Request for Additional Information

DA Online Reference Number: PAN-193944

Environmental protection works – proposed rock rip rap and associated revegetation works along the Murray Riverbank

Lot 4&5 of DP560393, 131 Merool Road Moama NSW 2731

Client:		Project:		Drawing Status:	
		MEROOL RIVER BANK REHABILITATION		FOR REVIEW	
FIFTEEN 50		Title:			
		SITE 1 - PLAN AND CROSS-SECTION		Drawing No.	Rev.
				21091-02	B
				Sheet.	
				02/06

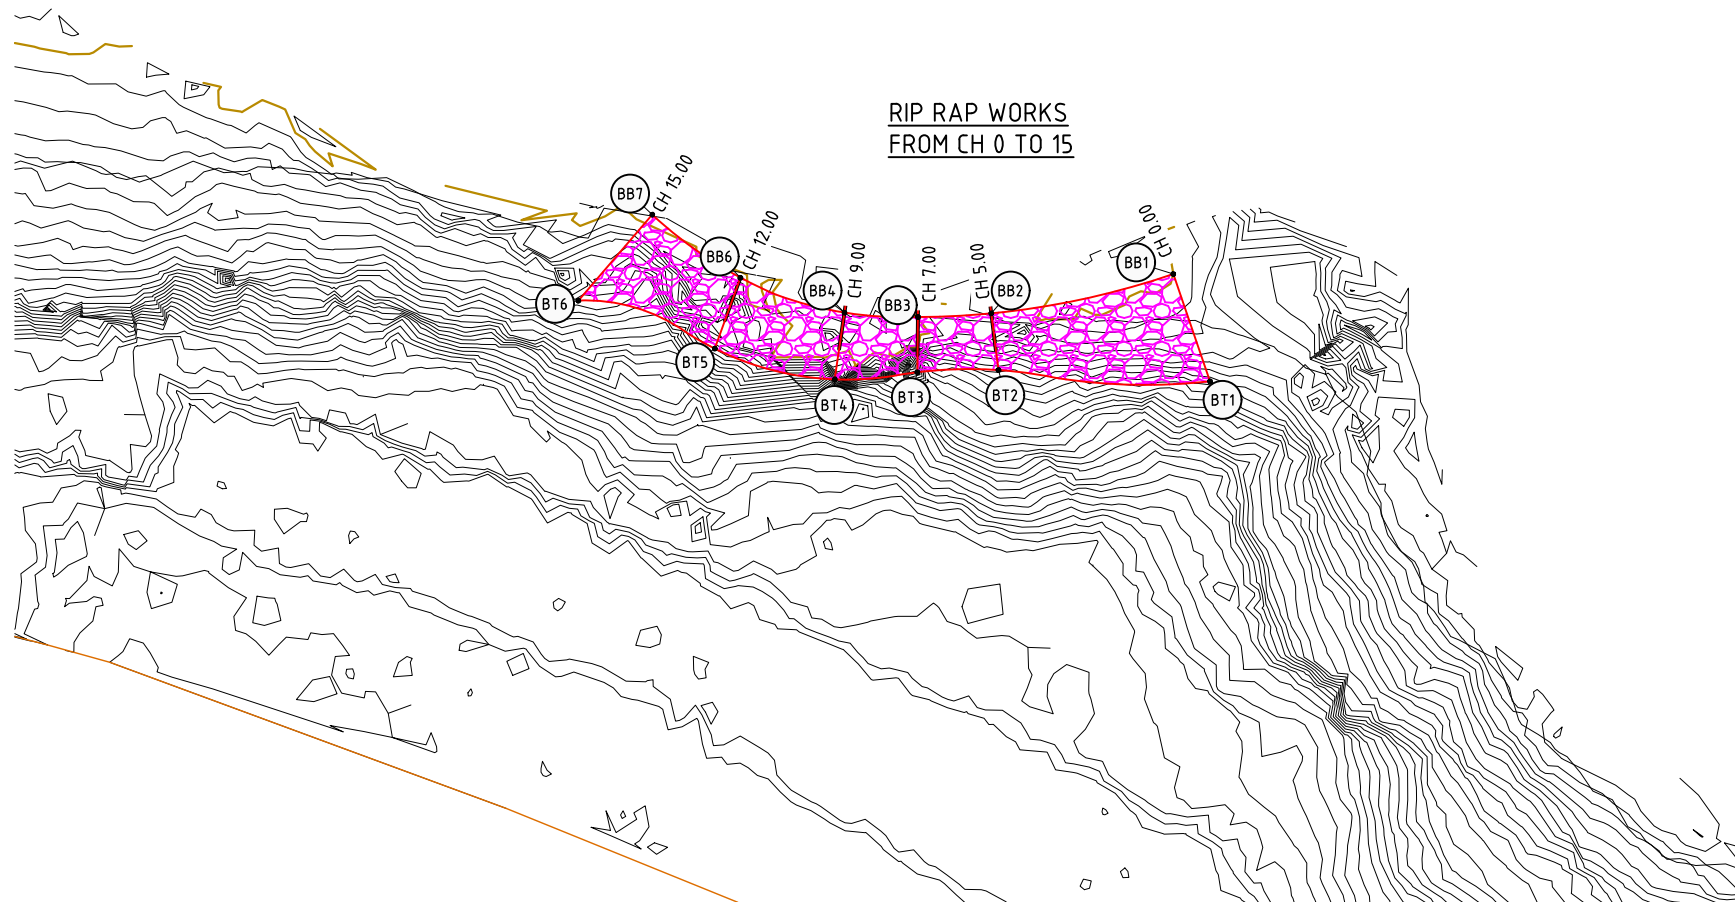
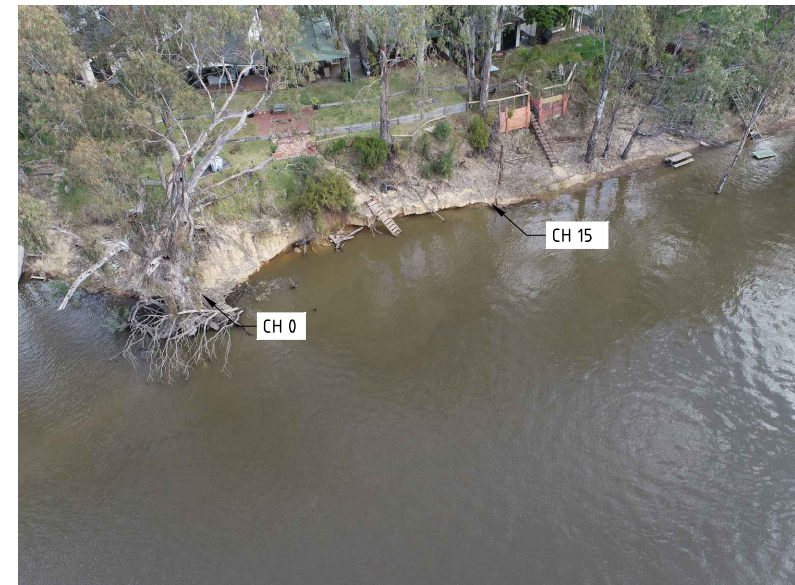
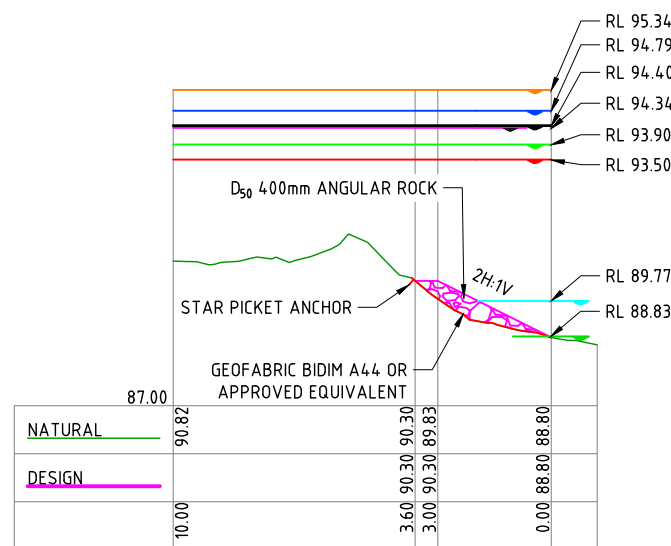
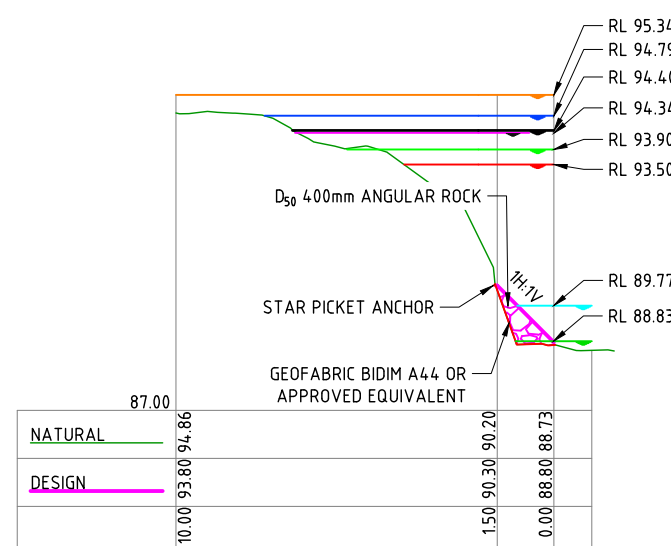
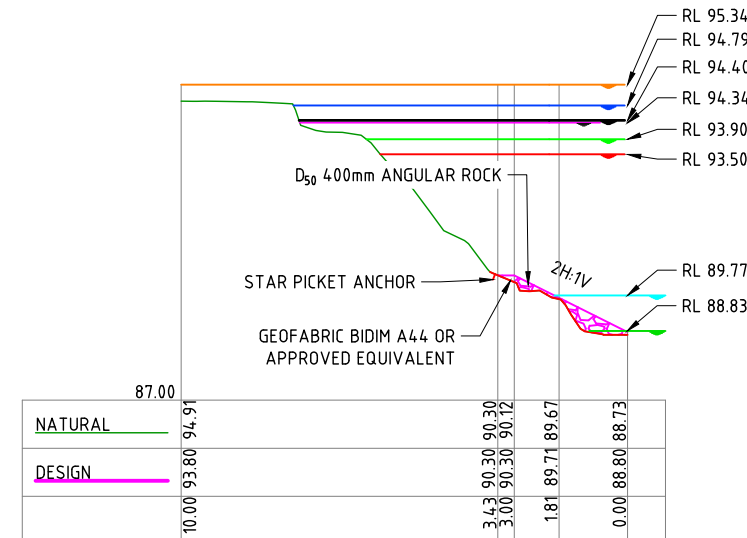
1. Proposed site plan
 - Amended proposed site plans are required
 - Site 1- Plan and Cross Section; Drawing No 21091-02; Sheet 02 of 07 – total length of the proposed rock rip rap has been added. Please refer to updated drawing attached.

Project:	MEROOL RIVER BANK REHABILITATION
Title:	SITE 2- PLAN

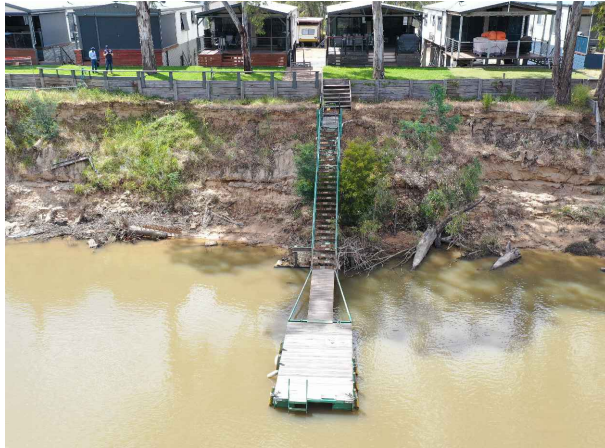
- Site2- Plan; Drawing No 21091-03; Sheet 03 of 07 – total length of the proposed rock rip rap and the scale has been added. Please refer to updated drawing attached.
